Errata 4 to TS 102 796 V1.4.1 and Errata 1 to TS 102 796 V1.5.1

2020-07-31

This document contains the currently identified and resolved errata to ETSI TS 102 796 v1.4.1 and V1.5.1. It is a living document which will be updated based on experience of implementing receivers, services and tests. Versions of this document will periodically be made publicly available via the www.hbbtv.org web site.

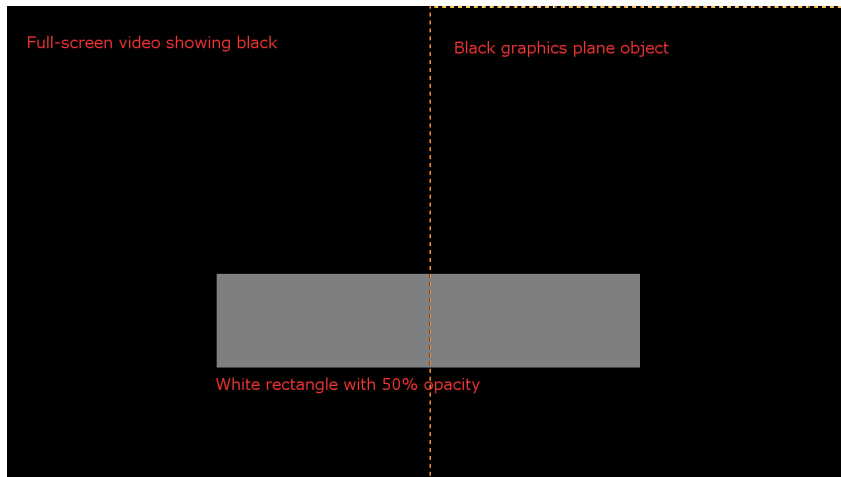
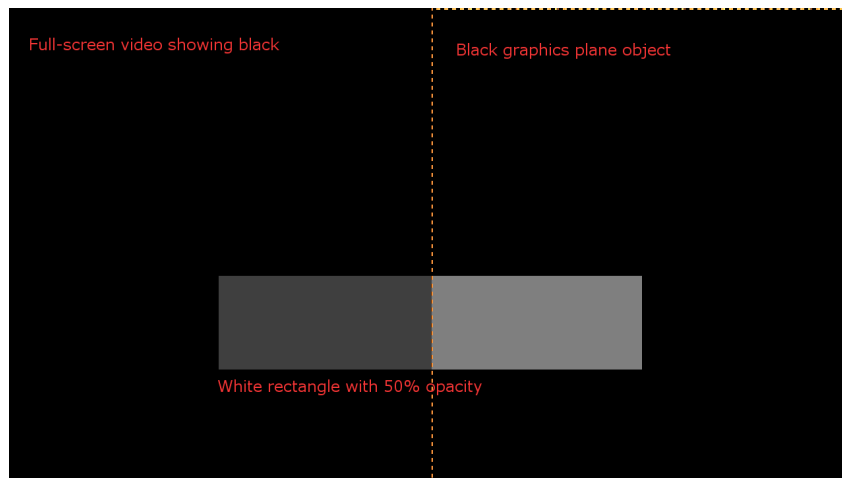
> NOTE 2:   The compositing equations defined in CSS produce pixels represented in "alpha pre-multiplied form", whereby the R, G and B colour values of the pixel are each "pre-multiplied" by the pixel's resulting alpha value. For example, a white pixel with 50% opacity on a 32-bit graphics plane would be represented by pixel values of (127,127,127,127) in pre-multiplied form, and not (255,255,255,127). This representation of pixels is commonly used for alpha blending to avoid the need for division. However, care is needed to account for this when compositing a graphics plane over a video plane. If the graphics plane pixels are left in alpha pre-multiplied form, then this must be taken into account when the graphics plane is combined with the video plane. Typically, this will involve setting an appropriate configuration on a hardware compositor.

EXAMPLE 1:   A video is playing full screen and an opaque image covers the right-hand half of the picture such that the displayed colours match. When a semi-transparent graphics-plane element is placed over both the video and the image, the colour also matches.

The following figure illustrates this with black video and an opaque black image:

The following figure shows a possible incorrect rendering in which the graphics and video have been composited without taking into account that the graphics plane is in alpha pre-multiplied form:
